LAND USE APPLICATION COMPLETENESS REVIEW

Second Review Comments

Subject Property: 1105 Front Street NE

Reference Nos.: 24-106451-PLN (Class 3 Site Plan Review, Tentative Subdivision Plan, Class 1 & 2 Adjustment, Class 2 Driveway Approach Permit)

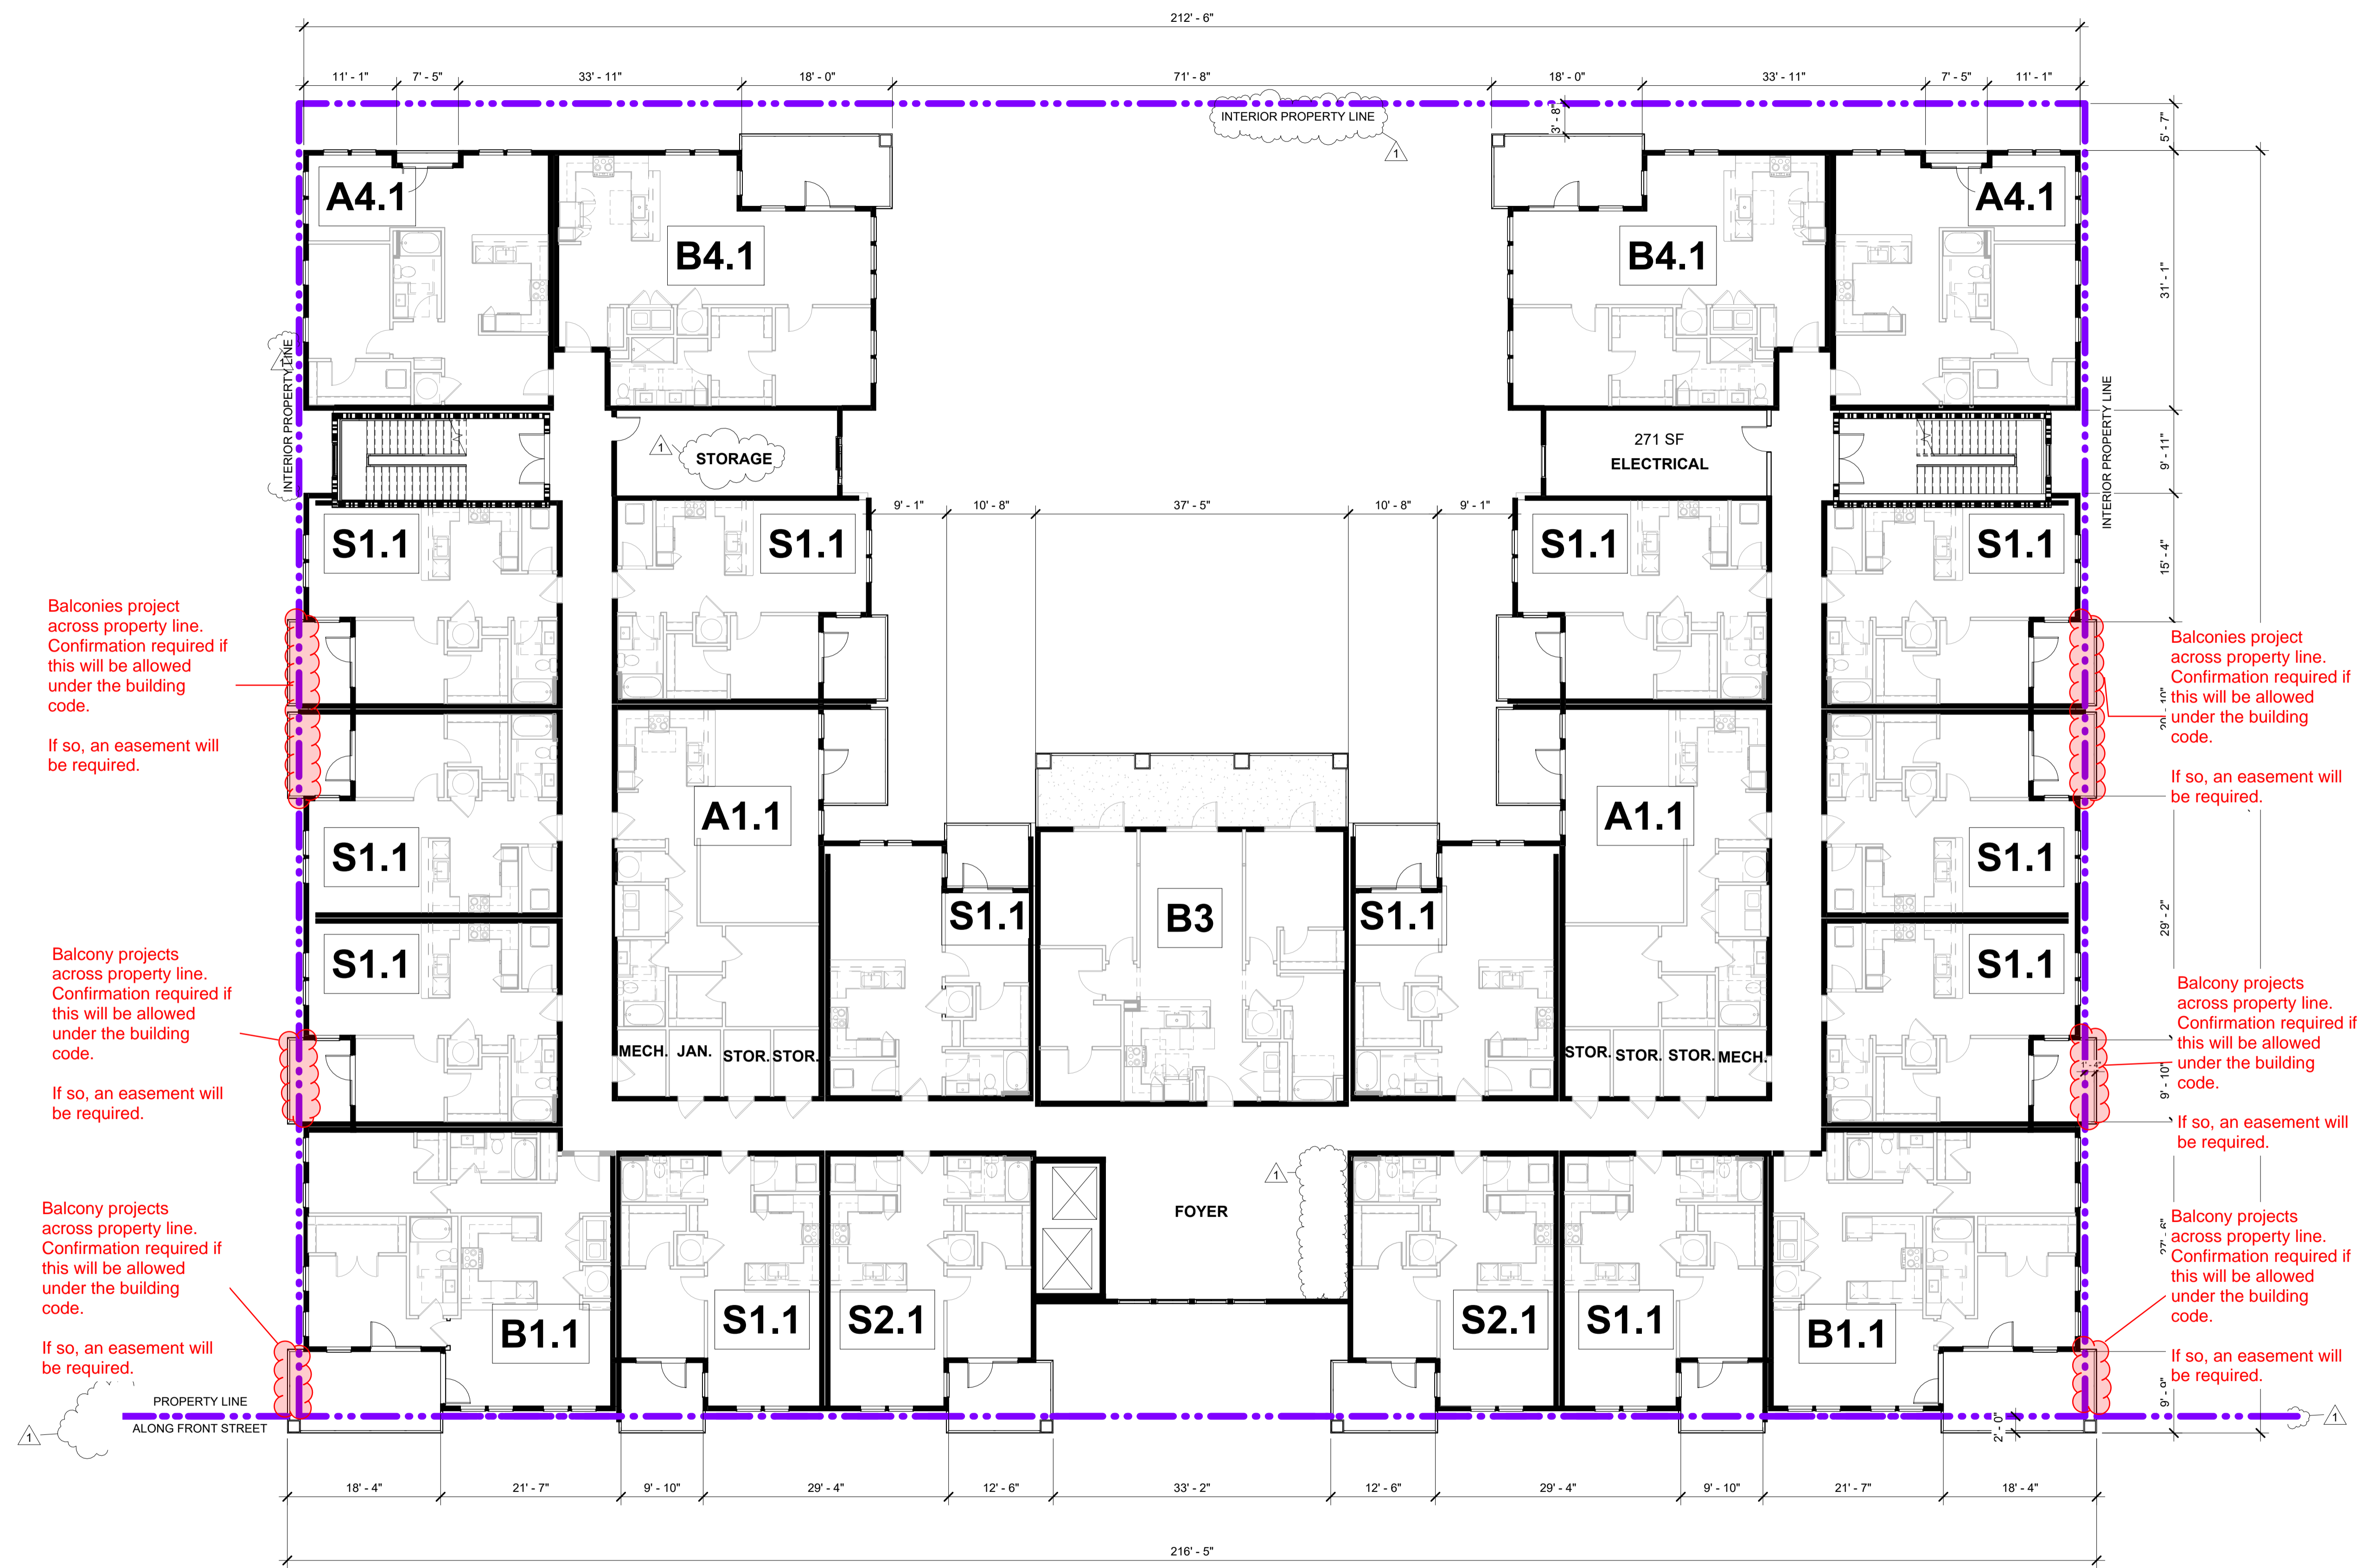
Balconies project across property line. Confirmation required if this will be allowed under the building code.
If so, an easement will be required.

Balcony projects across property line. Confirmation required if this will be allowed under the building code.
If so, an easement will be required.

Balcony projects across property line. Confirmation required if this will be allowed under the building code.
If so, an easement will be required.

Balconies project across property line. Confirmation required if this will be allowed under the building code.
If so, an easement will be required.

Balcony projects across property line. Confirmation required if this will be allowed under the building code.
If so, an easement will be required.

Balcony projects across property line. Confirmation required if this will be allowed under the building code.
If so, an easement will be required.

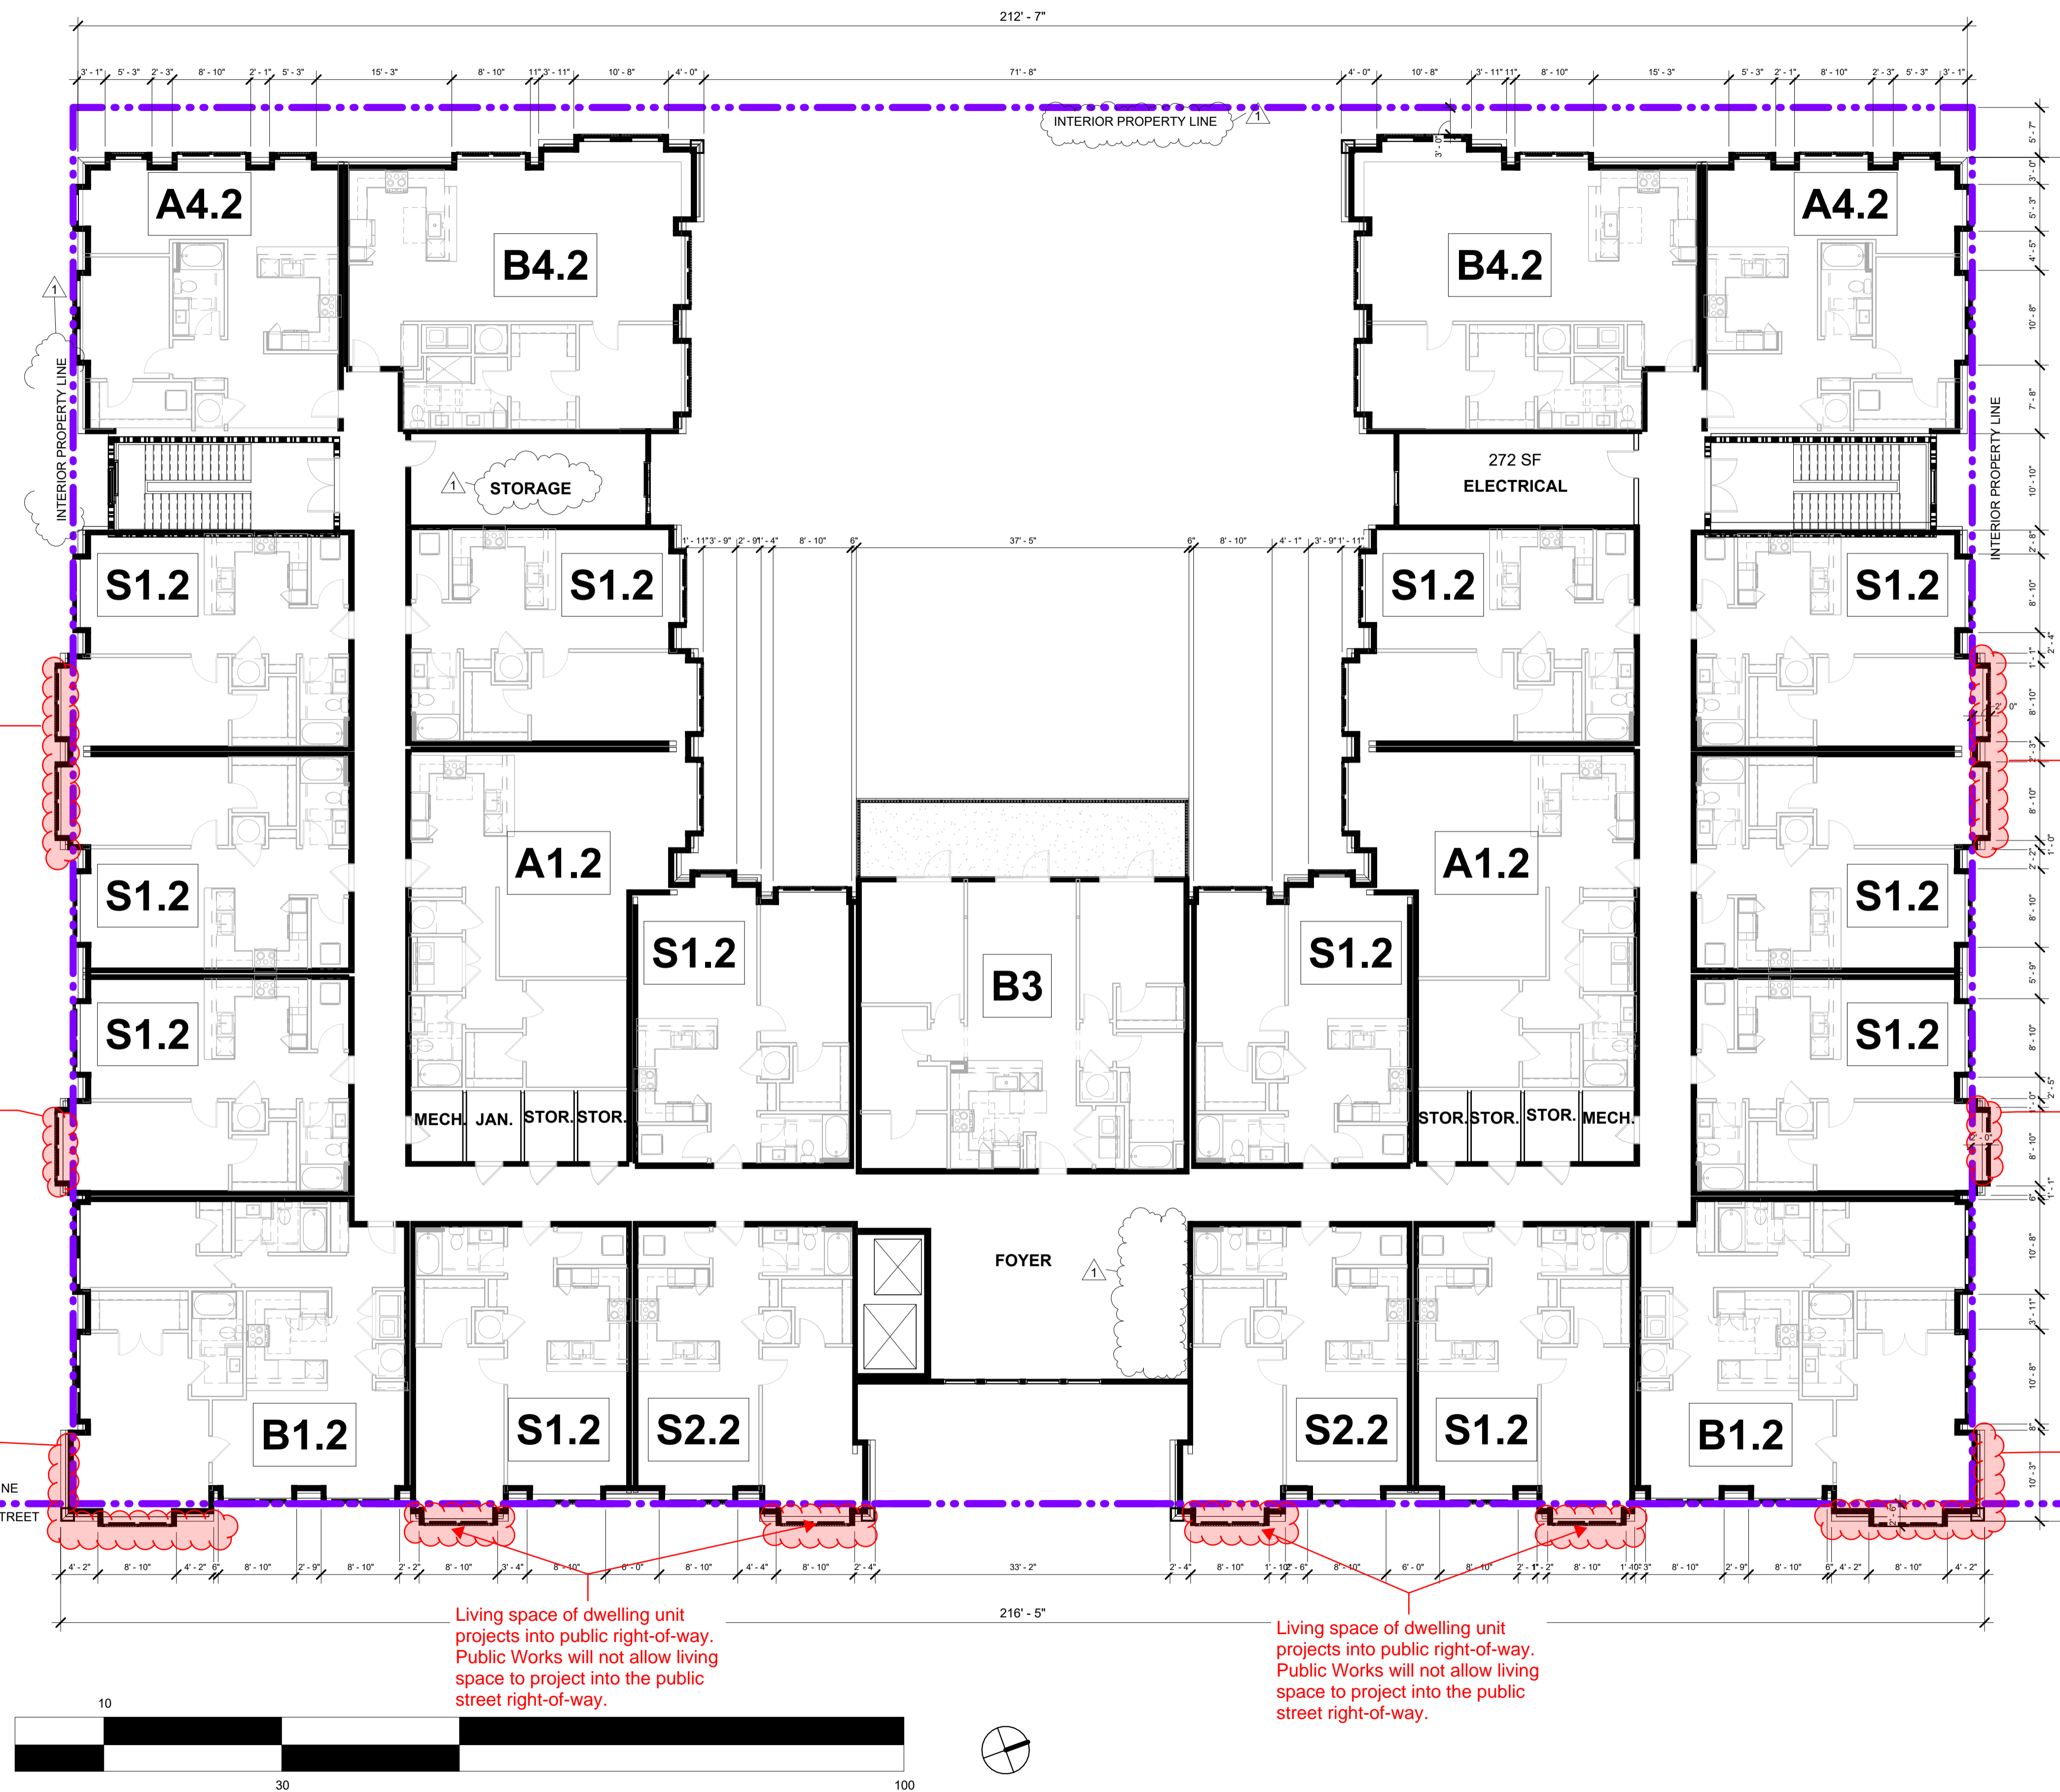
Living space of dwelling units project across property line. Confirmation required if this will be allowed under the building code.
If so, an easement will be required.

Living space of dwelling unit projects across property line. Confirmation required if this will be allowed under the building code.
If so, an easement will be required.

Living space of dwelling unit projects across property line and into the public street right-of-way.
Public Works will not allow living space to project into the public street right-of-way.
If the building code will allow this portion of the building to project across the south property line, an easement will be required.

Living space of dwelling unit projects into public right-of-way. Public Works will not allow living space to project into the public street right-of-way.

Living space of dwelling unit projects into public right-of-way. Public Works will not allow living space to project into the public street right-of-way.

Living space of dwelling units project across property line. Confirmation required if this will be allowed under the building code.
If so, an easement will be required.

Living space of dwelling unit projects across property line. Confirmation required if this will be allowed under the building code.
If so, an easement will be required.

Living space of dwelling unit projects across property line and into the public street right-of-way.
Public Works will not allow living space to project into the public street right-of-way.
If the building code will allow this portion of the building to project across the north property line, an easement will be required.
